INITIAL FIRE SAFETY INSPECTION REPORT

Al-Muslim Washing Ltd. & Al-Muslim Garments Accessories Ltd (Extension)

RSC ID: 25608

Date: 24 March-2024

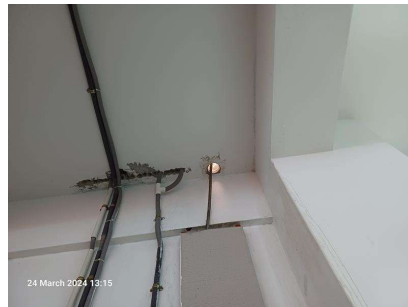
Findings & Recommendations:				
SI No.	Category	Findings	Required Action	Remediation Time Frame
F-01	Fire rated Construction	<p>Areas used for combustibile storage open to the factory are not separated by fire rated construction.</p> <p>Location: 2nd floor, 3rd floor and 5th floor of ETP Building-II (Building-5)</p> <p>3rd and 4th floor of Yarn Dyeing Building (Building-6)</p> <p>Ground floor and 1st floor of Washing Building -05 (Building-7)</p>	<p>Separate the dedicated storage rooms by minimum 1-hr fire-rated construction. Provide 0.75 hr. fire rated door and seal all penetrations and openings by 1 hr. fire rated fire rated barrier construction.</p> <p>Where separate storage rooms are not feasible, provide defined storage areas and limit the storage arrangement as follows: Where the building/floor is sprinkler protected: maximum height of 3.66m (12ft.) and maximum area of 93m2 (1000 ft2) and 3m (10ft.) clear distance from adjacent another unenclosed combustibile storage.</p>	Within 3 months

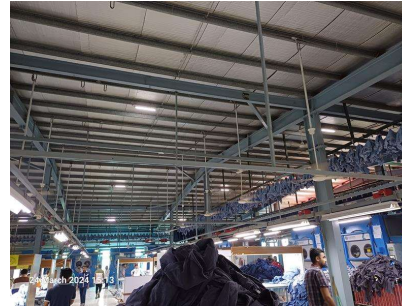
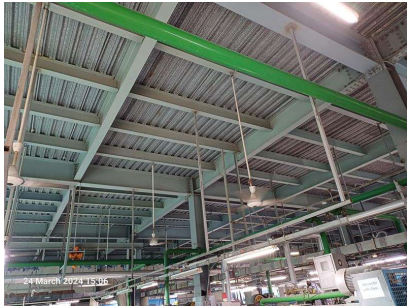
F-03	Fire rated Construction	<p>Storage rooms discharges directly into exit stair enclosure.</p> <p>Location: 5th floor stair-4 of ETP Building-II (Building-5)</p> <p>Both stair of 4th and 5th floor of Yarn Dyeing Building (Building-6)</p>	<p>Openings from the exit enclosure to the storage room, shall be provided with a vestibule with fire-rated construction and openings.</p> <p>Provide a 1 hr. fire rated door on the exit stair side and a 1- hr. fire rated door on the storage room side. Ensure that the fire rating of the vestibule construction matches that of the exit stair enclosure.</p>	Within 3 months

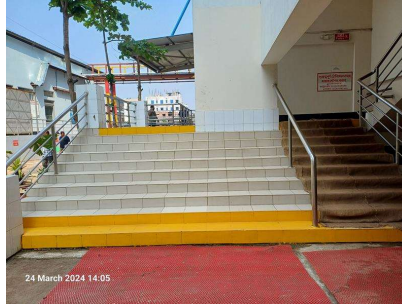
F-06	Fire rated Construction	<p>Unprotected elevator or lift shaft openings located at floor due to non functional hardware of the fire rated door.</p> <p>Location: ETP Building-II (Building-5), Yarn Dyeing Building (Building-6).</p>	<p>Ensure the lift shaft is enclosed by a minimum 3-hour fire-rated wall with a minimum 2.0-hr fire-rated door and the fire doors are self-closing and positive latching and that they are provided with fire exit (panic) hardware.</p> <p>If fire doors are required to be held open for functional reasons, provide automatic closing devices tied to the fire alarm system.</p>	Within 3 months
